# UNITED STATES PATENT AND TRADEMARK OFFICE

APPLICATION NO.	FILING DATE	FIRST NAMED INVENTOR	ATTORNEY DOCKET NO.	CONFIRMATION NO.
10/705,355	11/10/2003	Jee-Won Jeong	5000-1-478	4616
33942 7590 04/06/2007 CHA & REITER, LLC 210 ROUTE 4 EAST STE 103 PARAMUS, NJ 07652			EXAMINER MIRZADEGAN, SAEED S	
			ART UNIT	PAPER NUMBER
			2109	
SHORTENED STATUTORY PERIOD OF RESPONSE		MAIL DATE	DELIVERY MODE	
3 MONTHS		04/06/2007	PAPER

## Office Action Summary

**DETAILED ACTION*****Drawings***

**FIG. 7**

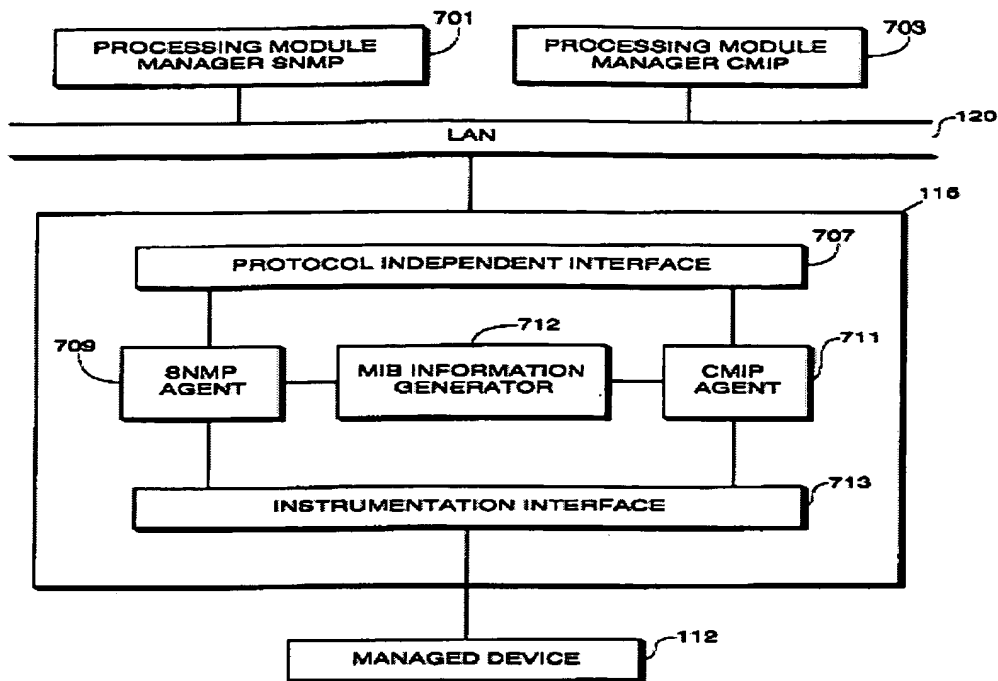
10. Regarding **Claim 1**, Villalpando discloses, An NE (Network Element) system for providing an independent multi-protocol service, comprising: a plurality of NEs for configuring a network (**Col. 2, line 61, teaches a networked computer system**); management systems for supervising operations (**Col. 2, lines 62 & 64-66, teaches processing modules that manage the peripheral devices**) of the plural NEs and providing services for the NEs (**Col. 2, lines 66-67, teaches one or more peripheral devices**); and a domain service bridge arranged between the NEs and the management systems, wherein the domain service bridge is coupled to the NEs through a protocol for use in the NEs, and the domain service bridge is coupled to the management systems through protocols corresponding to the management systems (**Fig. 7 & Col. 3, lines 2-6) teaches a generating unit coupled between the managed peripheral devices and the processing modules.**

**FIG. 1**  
**PRIOR ART**

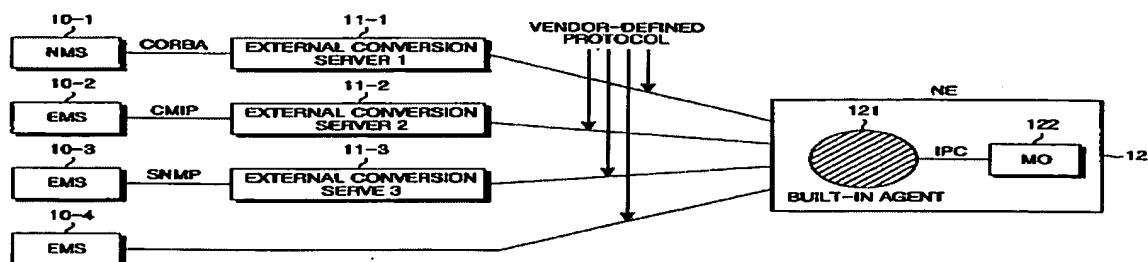
34. Regarding **Claim 8**, Fig.1, admitted as prior art by the applicant shows protocols corresponding to the management systems comprise SNMP (Simple Network Management protocol) & CMIP (Common Management Information Protocol) and CORBA (Common Object Request Broker Architecture) protocol.

39. Regarding **Claim 18**, Fig.1, admitted as prior art by the applicant shows protocols corresponding to the management systems comprise SNMP (Simple Network

55. Regarding **Claim 20**, Fig.1, admitted as prior art by the applicant and **(page 3, lines 8-9) teaches the external conversion servers 11-1, 11-2 and 11-3 convert a protocol used in the NE 12 into a protocol used in the NMSs 10-1, 10-2, 10-3 and 10-4.**
